Assessment of the Jabiluka Project

Report of the Supervising Scientist

World Heritage Committee

Figure 3.3.1 Comparison of average monthly storage evaporation estimates and point potential and areal potential evapotranspiration rates

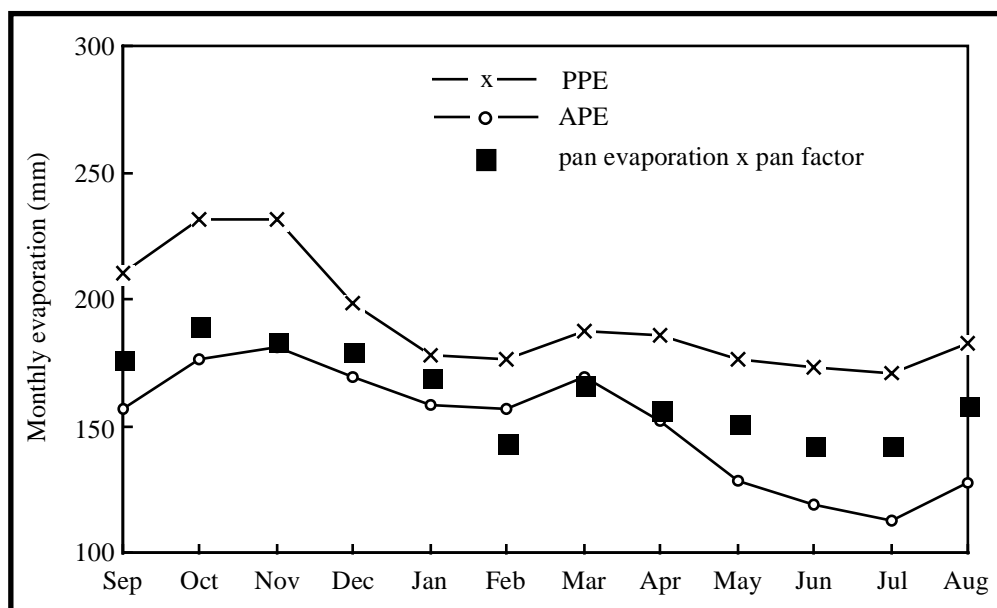
Wasson et al (1998) note the use by ERA of two simple seasonal factors to estimate pond evaporation from pan measurements; 0.6 in the Dry season (May–October) and 0.75 in the Wet season (November–April). They assert that there is a need to check these factors by appropriate modelling that incorporates existing solar radiation data and that the extensive evaporation study conducted at Manton Dam, south of Darwin, needs to be taken into account.

The approach outlined above was adopted by ERA in the draft EIS in 1996 but Wasson et al (1998) seem to have been unaware that ERA adopted a more sophisticated approach in the PER for the Jabiluka Mill Alternative. It was the proposal for the Jabiluka Mill Alternative, presented in 1998, which was the subject of investigations conducted by the Mission of the World Heritage Committee to Kakadu. ERA outlined in Appendix B1 of the PER the procedure adopted in estimating evaporation from the retention pond. Pan factors for each month of the year were adopted following a review of all existing evaporation data relevant to the region by CSIRO (Hatton 1997). The conclusion of Hatton (1997) was that, with the exception of the two months of April and October, the pan factors derived by the Supervising Scientist (Vardavas 1987) should be used in all water balance calculations.

Figure 3.3.1 shows the evaporation rates calculated using the Vardavas (1987) pan coefficients and these are compared to the APE and PPE values. All of the Vardavas calculations are in agreement with the seasonal pattern of the APE and the PPE. For February and March, the estimated storage evaporation rates are lower than the APE and Chiew and Wang (1999) concluded that this could be due to errors in the recorded pan evaporation (because of the difficulty in accurately estimating pan evaporation when rainfall is high) or errors in the APE estimates. The overall conclusion was, however, that the best estimates of pond evaporation for Jabiluka would be obtained by using the results of Vardavas (1987).

Figure 3.3.2 Relationship between evaporation and rainfall at Jabiru for the months of January, February and March

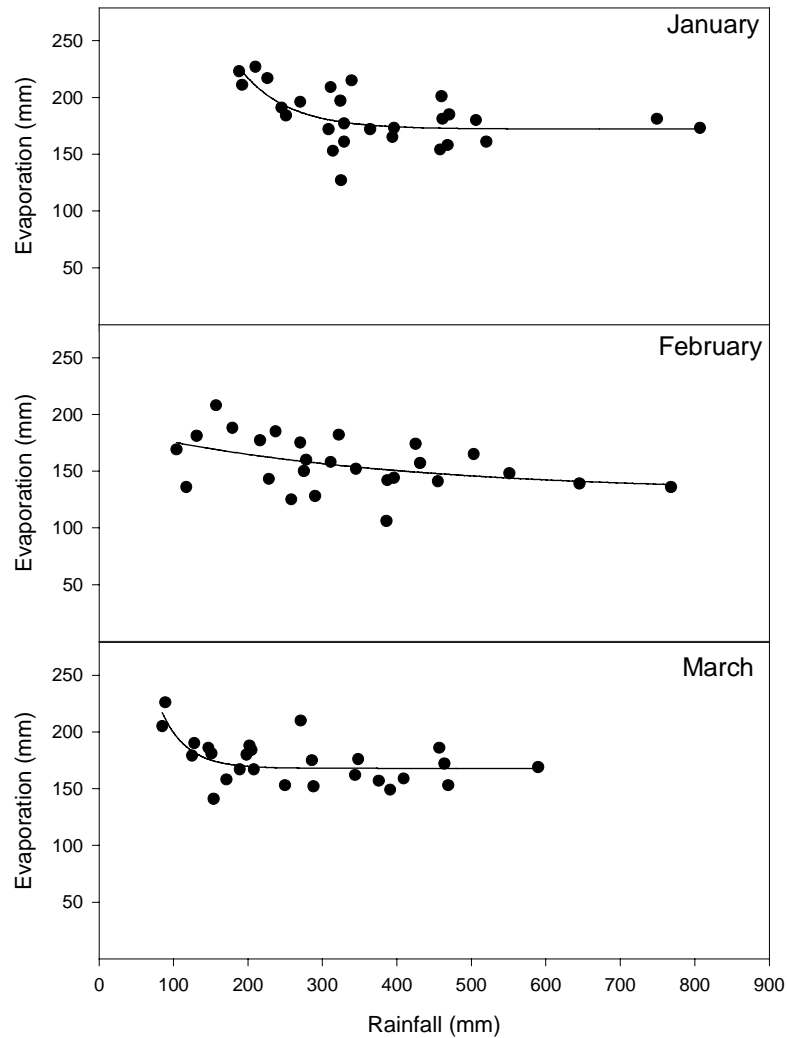
Wasson et al (1998) state that the principal source of error in the evaporation calculations of ERA arises from neglect of the inverse relationship between evaporation and rainfall which arises because solar radiation is lower on cloudy days than on sunny days. They suggest that the adoption of long-term mean values for the pan factors will result in a significant over-estimate of evaporation in very wet months and that this effect could exceed 10% during very wet years.

Chiew and Wang (1999) investigated the significance of the inverse relationship between evaporation and rainfall using data from a number of meteorological stations in the north of the Northern Territory including Jabiru, Maningrida, Middle Point and Darwin. They found that a linear inverse relationship was statistically significant for both the annual data and the quarterly data at each station and that it was most significant at Jabiru. They concluded that this effect should be taken into account in their modelling of the water management system at Jabiluka and they evaluated the significance of the effect on the required pond volume. The conclusion reached was that the retention pond volume would need to be increased by about 3% as a result of both the inverse relationship and interannual variability in evaporation.

There is, however, evidence that even this small effect is an over-estimate because, during the principal months of the Wet season (December to March), cloud cover is often extensive even when there is no rainfall. As a result, the relationship between evaporation and rainfall during any given month will not be linear but evaporation will tend towards a constant lower value at higher rainfall values. This effect is clearly illustrated in figure 3.3.2 where evaporation at Jabiru is plotted against rainfall for the principal Wet season months of January, February and March. The line through the data in each case is of the form

Figure 3.4.1 Variation of saturated vapour pressure (upper graph) and absolute humidity (lower graph) with temperature at atmospheric pressure $P=100\text{kPa}$

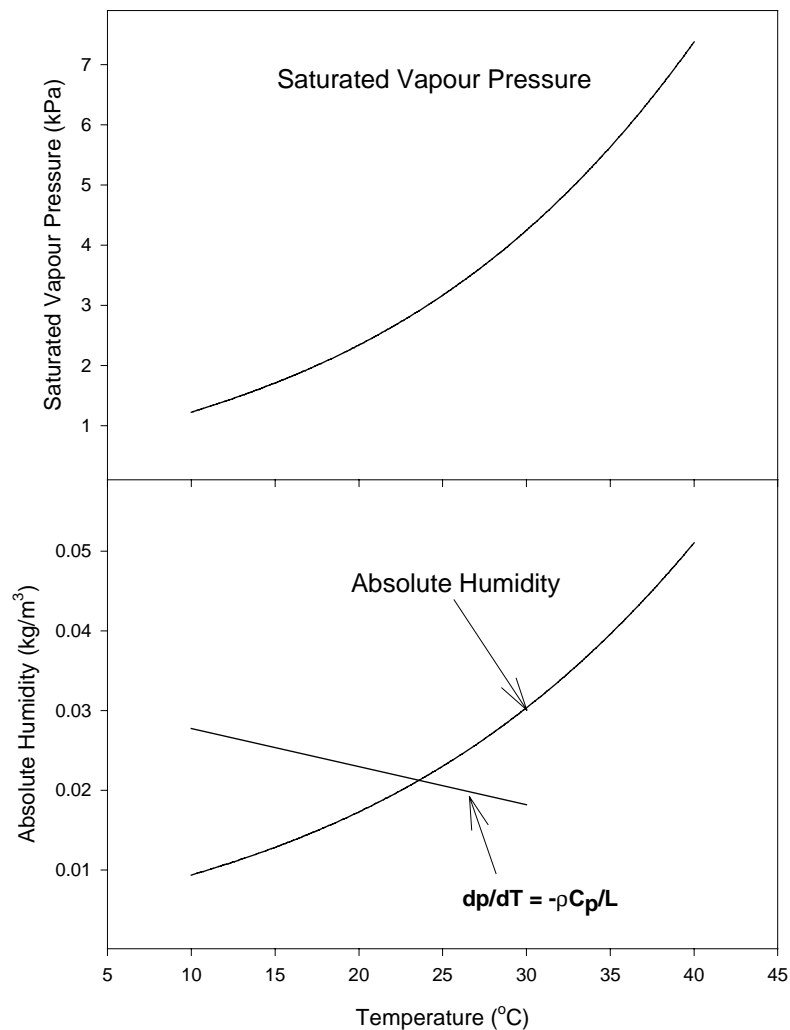
where Δp is the change in humidity, L is the latent heat of vaporisation, ρ is the density of air and C_p is the specific heat of air. Using $L = 2.43 \cdot 10^6 \text{ J/kg}$ (Kaye & Laby 1978, p 235), $\rho = 1.149 \text{ kg/m}^3$ (Kaye & Laby 1978, p 18) and $C_p = 1010 \text{ J/kg}^\circ\text{C}$ (CRC 1995, p 6-1), the decrease in temperature resulting from the vaporisation of the water would be 16°C . As can be seen from figure 3.4.1, the absolute humidity (ie fully saturated) at 14°C is about 0.012 kg/m^3 , a figure considerably less than the initial vapour density. Hence, the target evaporation figure cannot be achieved.

For 60% relative humidity, $p_0 = 0.0182(\text{kg/m}^3)$ at $T_0 = 30^\circ\text{C}$. This line is shown in figure 3.4.1. It intercepts the graph of absolute humidity at about 23.6°C which, as proposed by Wasson et al (1998), is the wet bulb temperature (estimated as 23.8°C from the data in CRC (1995) p15–22). At this temperature the absolute humidity is $0.0213 (\text{kg/m}^3)$. Thus the maximum quantity of water that can be evaporated is

This value is about 40% of the design value presented in Appendix J of the draft EIS.

These observations, however, do not imply that a major error exists in the proposal put forward for water management at the Jabiluka mine. If the latent heat of evaporation were to be supplied (for example, by standard humidifiers) there would be no need to take the above drop in temperature into account and the volume of water that could be evaporated would remain that estimated in the EIS and the PER. The Supervising Scientist consulted the engineer who advised ERA on this issue (Mr Douglas Rudd, Kinhill Pty Ltd) who advised that the calculations were provided to indicate the capacity of the ventilation system to dispose of additional water through evaporation. It was recognised that energy input via heaters, hot air blowers or staged misting/humidifiers would be required to achieve the full indicated disposal volume. These issues were, however, matters to be dealt with at the detailed design stage of the project when the potential of this method of water disposal could be evaluated (ie a cost benefit analysis) in a comparison with other methods such as increasing the area of the retention pond.

The area of the retention pond would need to rise from 9 ha to approximately 13 ha to provide the required evaporative capacity if no evaporation occurs in the ventilation shafts. This area is small compared to the total area of retention and tailings ponds proposed in the original JMA proposal and is only 2% of the disturbed area at the nearby Ranger mine. The environmental impact arising from such an increase, should it need to be part of the project, is, therefore, not considered to be significant.

Figure 4.4.1 Cusum plot for the annual rainfall records at Oenpelli showing low average rainfall from 1932–1952 and high average rainfall from 1970–1984

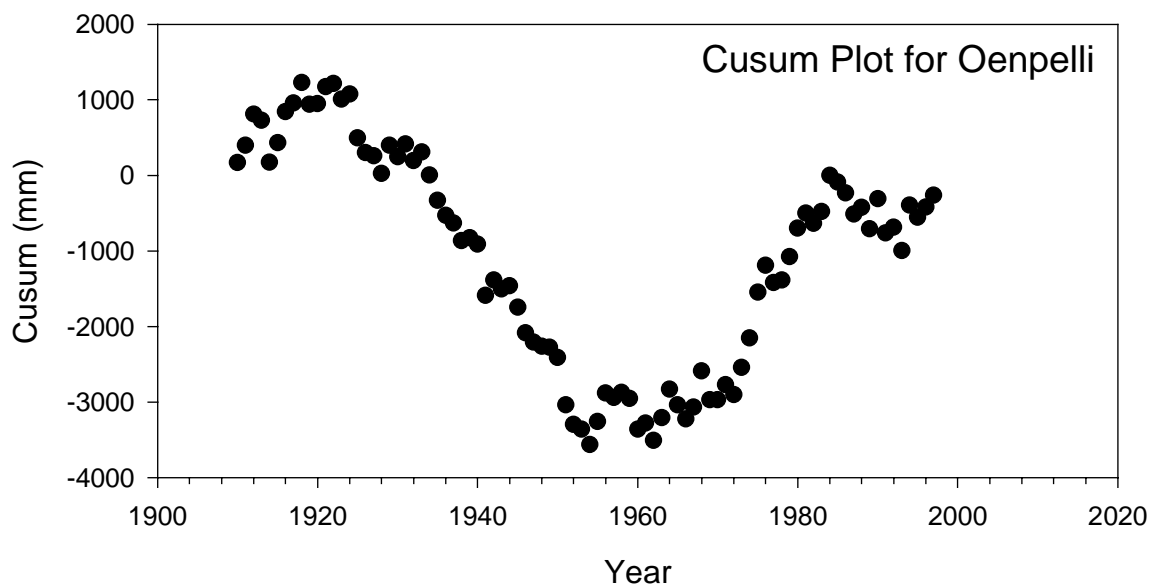
Thus, the response by ERA that greenhouse induced changes were not expected to be significant for hydrological modelling over the next 30 years has some justification because all of the coupled ocean models, which are considered to be more realistic, predicted a reduction in Wet season rainfall. However, until regional climate models are incorporated into the global climate models, this conclusion should be considered preliminary.

The *cusum* analysis for the Oenpelli data set, including rainfall records from 1991–1998, is shown in figure 4.4.1. It can be shown (eg Mittag & Rinne 1993) that the gradient of the *cusum* graph at time t is the difference between the mean at that time and the long-term mean. The data in figure 4.4.1, therefore, show that, at Oenpelli, there have been two extended periods in the past 87 years during which the mean annual rainfall for the period has been significantly different from the long-term mean annual rainfall. From 1932–1952, the mean rainfall was about 1220 mm, lower than the long-term mean by about 13%. From 1970–1984 the mean rainfall was about 1600 mm, higher than the long-term mean by about 15%. It is clear that such decadal-scale variation in mean rainfall could have a significant impact on

Figure 5.2.1 Estimates of storage capacity required as a function of exceedence probability over the 30-year mine life under current climatic conditions

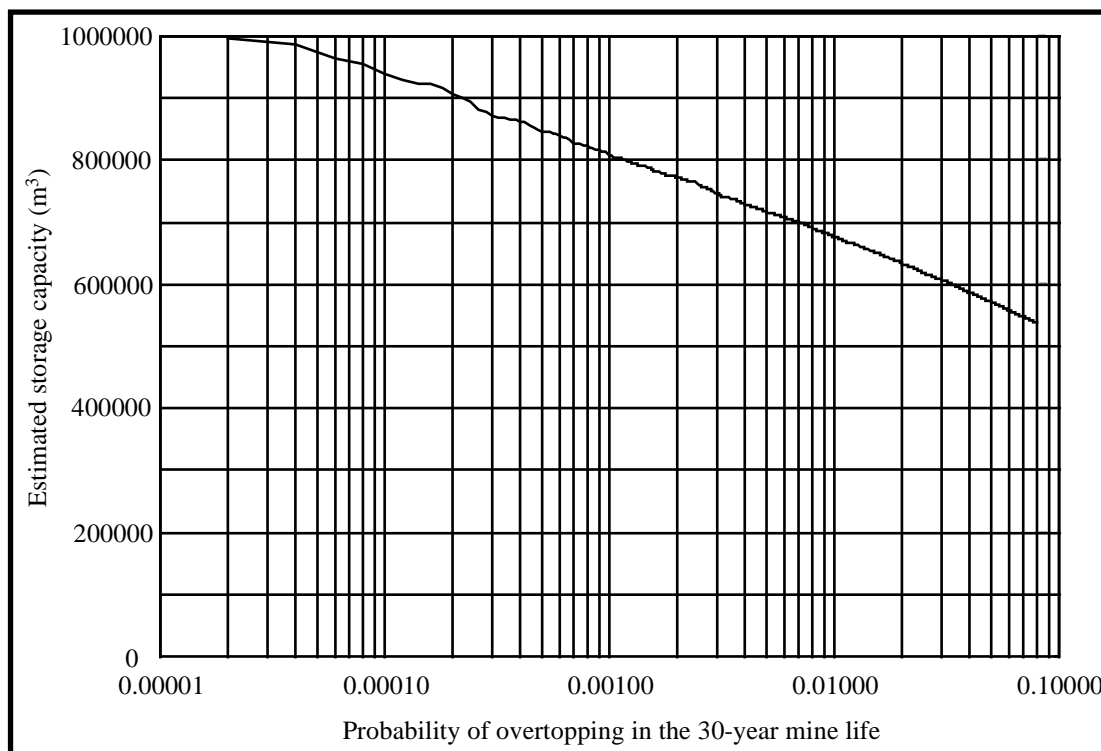
Figure 5.2.1 shows the estimates of storage capacity required as a function of exceedence probability over the life of the mine. The volume of pond proposed by ERA in the PER was 810,000 m³. (This is based upon a 9 ha pond of depth 9.5 m (PER p 4–52) of which 0.5 m is freeboard required to take into account wave action and is therefore not available for storage except under emergency conditions.) The data in figure 5.2.1 indicate that the probability of this storage capacity being exceeded in the life of the mine would be about 1:1,000. Based on these simulations, the estimate of storage capacity required to achieve an exceedence probability of 0.01% (1 in 10,000) over the 30-year mine life is 940,000 m³ (an equivalent depth of 10.4 m in the 90,000 m² storage area).
